Nonindustrial Timber Management Plan
No: 1-07NTMP-020
Amd: 1-07NTMP-020-DEV6
SWANTON PACIFIC RANCH NTMP

Letter of Conformance

Major Amendment: Reconstructed Road

AMENDMENT NO 6 (Major)
TO NTMP

Figure 1. Mitigation Point E (MPE) Sketch of Existing Condition

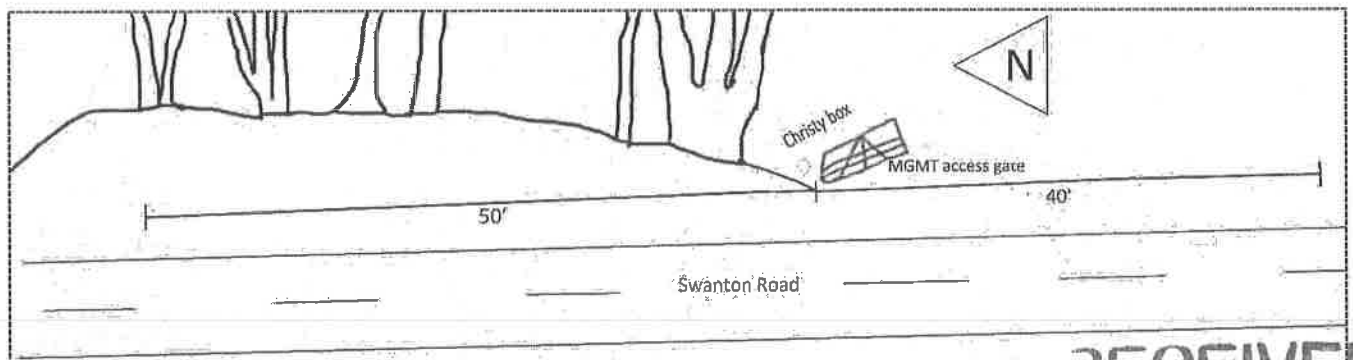
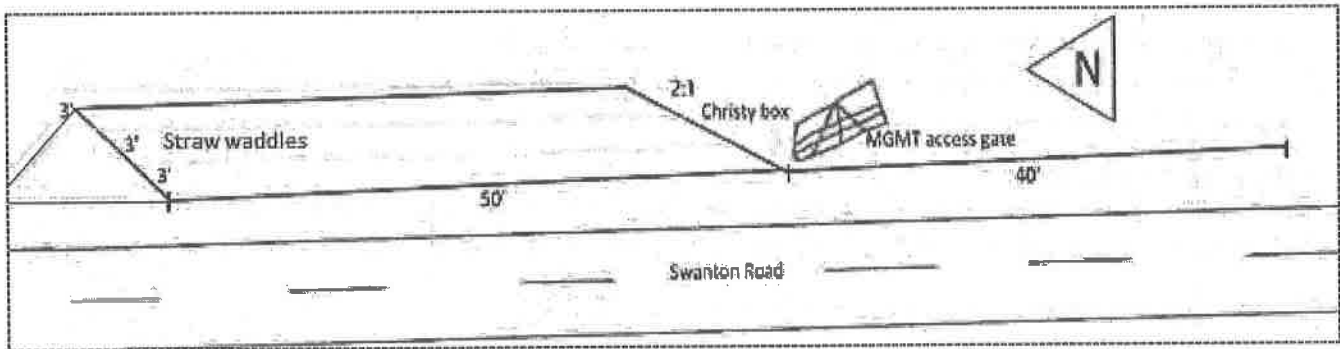
The location of this mitigation point is at the existing entrance on Swanton Road that accesses Landing L8. The mitigation addresses visibility onto Swanton Road. See Figures 1 and 2 for existing and desired future condition.

1. From the existing encroachment to the south, the LTO shall clear approximately 40 feet of brush to reasonably allow visibility for vehicles exiting onto Swanton Road.

2. From the existing encroachment to the north, the LTO shall remove vegetation, remove trees marked in blue (available for review at the PHI), and layback the slope at approximately 2:1 for 50 feet, to maximize visibility.

3. A buried drivable Christy box containing private utilities owned by Swanton Pacific Ranch is located approximately 5 feet from the gate at Swanton Road. The lines from the Christy box are approximately 3 feet underground and run up the middle of the road for approximately 260 feet through Landing L8. The Christy box may be covered with material during operations as needed to build up the entrance to Swanton Road. Following operations, the lid of the Christy box will be excavated and an extension will be added to match road grade, if necessary.

Figure 2. Mitigation Point E (MPE) Sketch of Desired Future Condition

Figure 3. Mitigation Point F (MPF) Sketch of Existing Condition

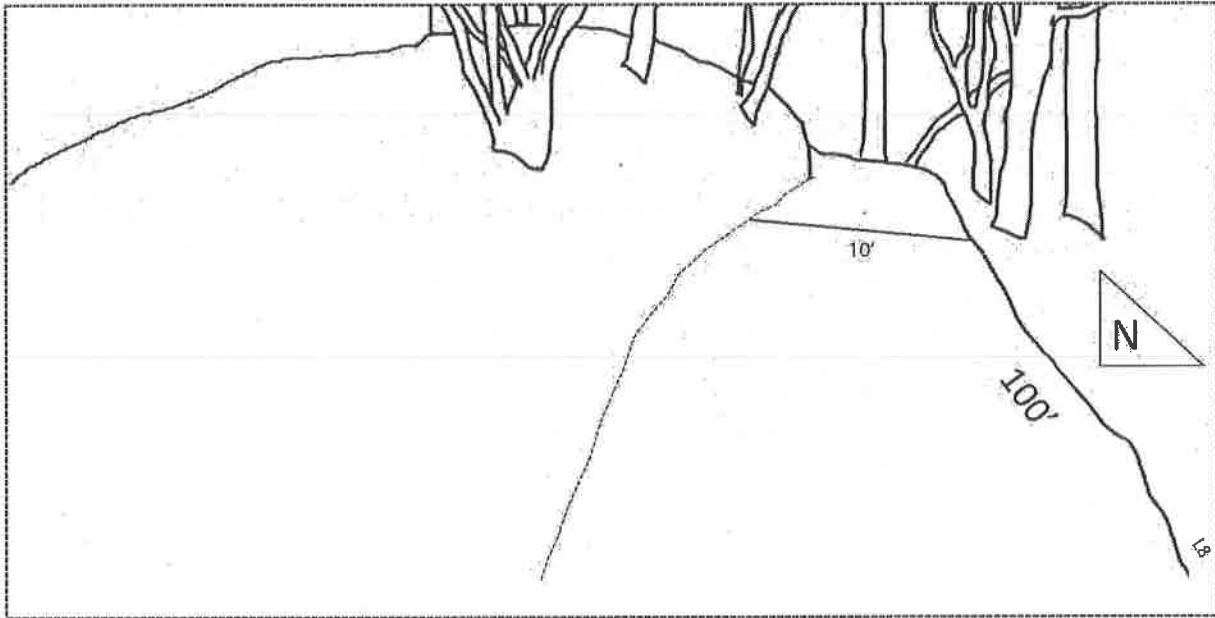
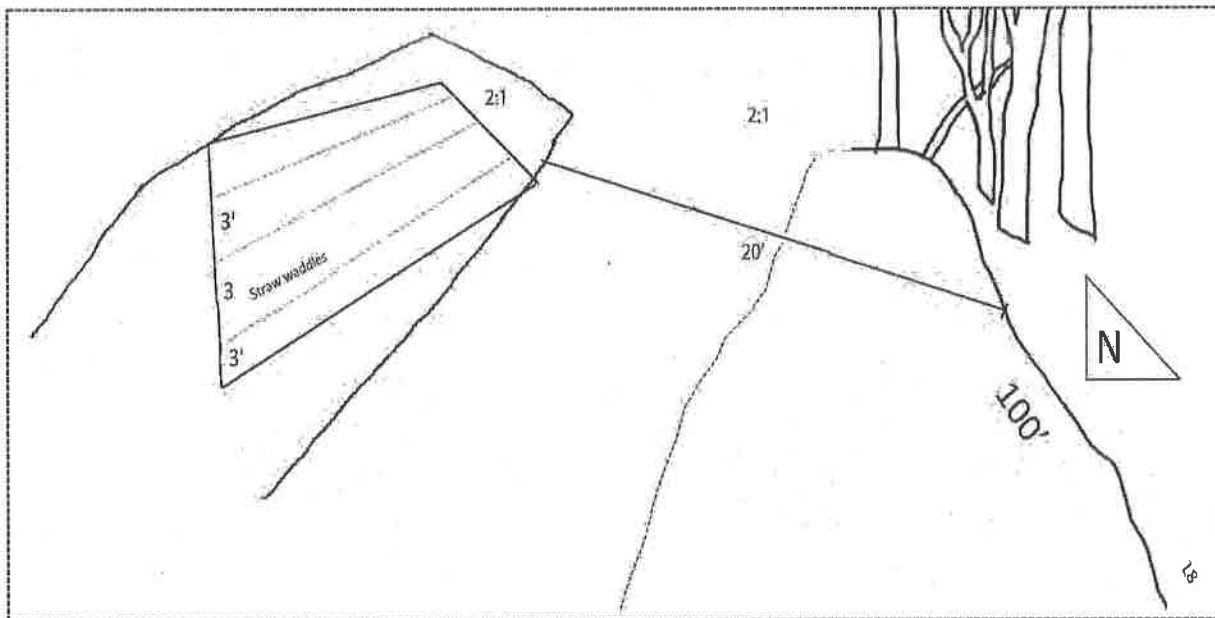
The location of this mitigation point begins just north of Landing L8 and extends southeast approximately 300 feet. Within this area, there is a 10-foot-wide section of existing road at a slope of approximately 15% for 120 feet. See Figures 3 and 4 for existing and desired future condition.

1. The eastern side of this existing road will be excavated to achieve a 20-foot-wide road. The remaining cutbank shall be laid back at approximately 2:1. The final reconstructed road grade will run at approximately 15% for 300 feet.
2. Harvested trees shall be placed in proximity to Landing L8, Landing L26, or in proximity to the reconstructed road, to be used for firewood if feasible.
3. Excess material from slope lay back, not utilized in balanced cut and fill construction shall be placed on or near Landing L8 or south of Landing L26 on slopes less than approximately 5%. Soil will be spread in uniform layers and compacted in 6 inch lifts, maintaining positive drainage away from the road.
4. Prior to the winter period or following operations Mitigation Point MPF shall be closed-out per the specifications in Soil Stabilization under Item 18, Section II of the NTMP.

Figure 4. Mitigation Point F (MPF) Sketch of Desired Future Condition

Figure 5. Mitigation Point G (MPG) Sketch of Existing Condition

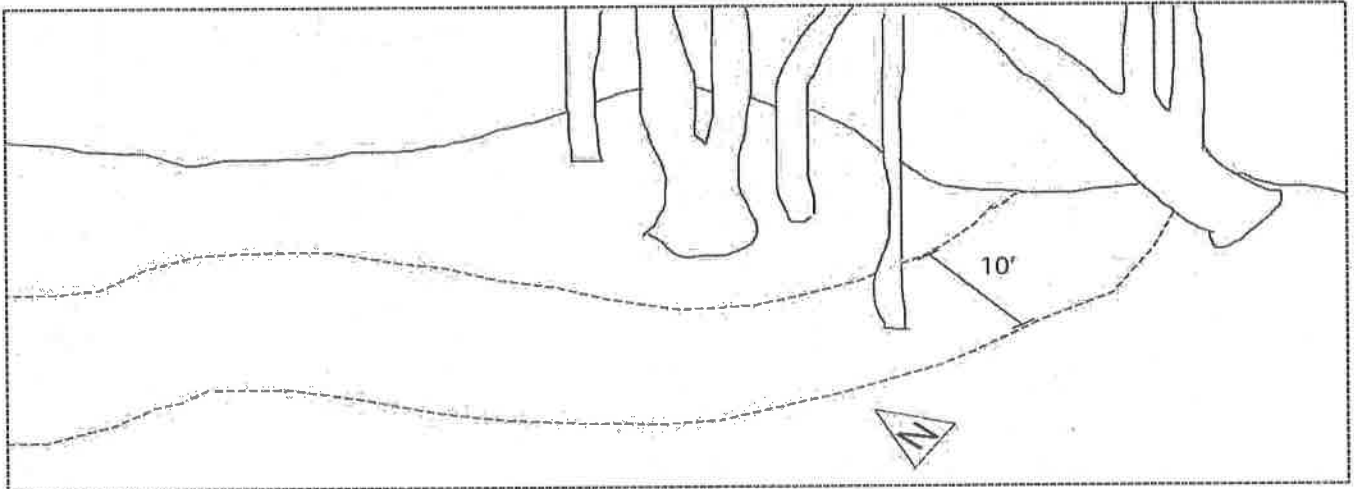
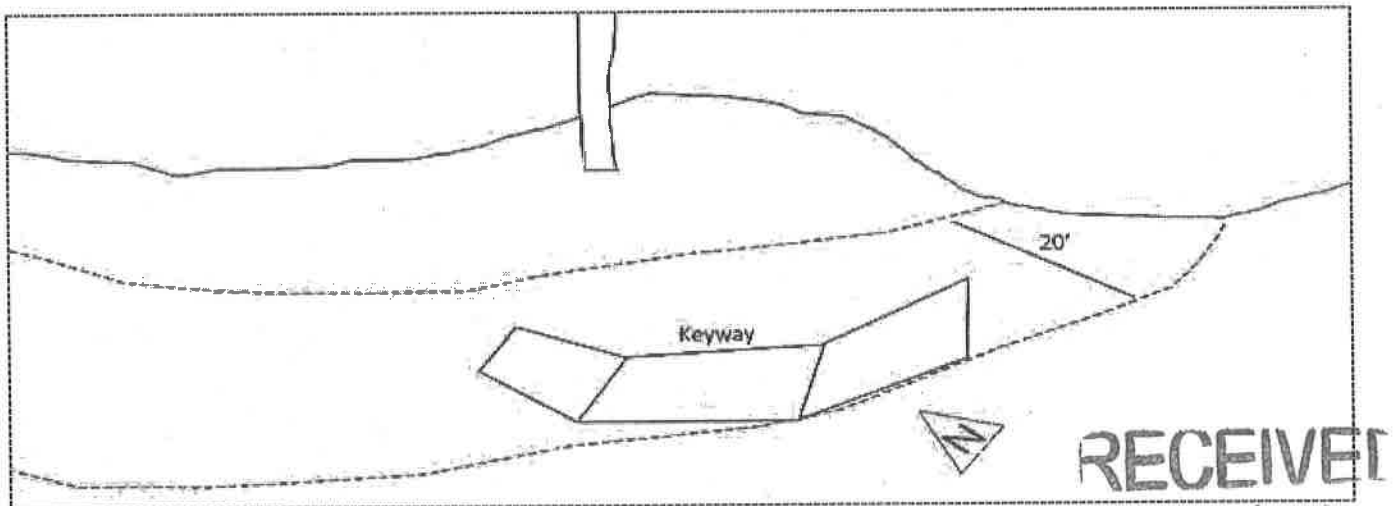
1. LTO shall remove trees marked in blue (available for review at the time of the PHI).
 - a. Harvested trees shall be placed in proximity to Landing 8, Landing 26, or within proximity to the reconstructed road to be used for firewood as feasible.
 - b. Excess material from slope layback, not utilized in balanced cut and fill construction of entry way, shall be placed on or near Landing 8 or Landing 26 on slopes less than approximately 5%.

2. The area adjacent the existing road will be sub-excavated approximately 2-3 feet to create a keyway for fill in order to transition the realignment onto OSHGR.
3. Soil will be compacted in approximately 6 inch lifts from the toe to the finished grade.
4. Prior to the winter period or following operations, the reconstructed road shall be closed-out per the specifications under Item 18, Soil Stabilization, in Section II of the NTMP.

Figure 6. Mitigation Point G (MPG) Sketch of Desired Future Condition
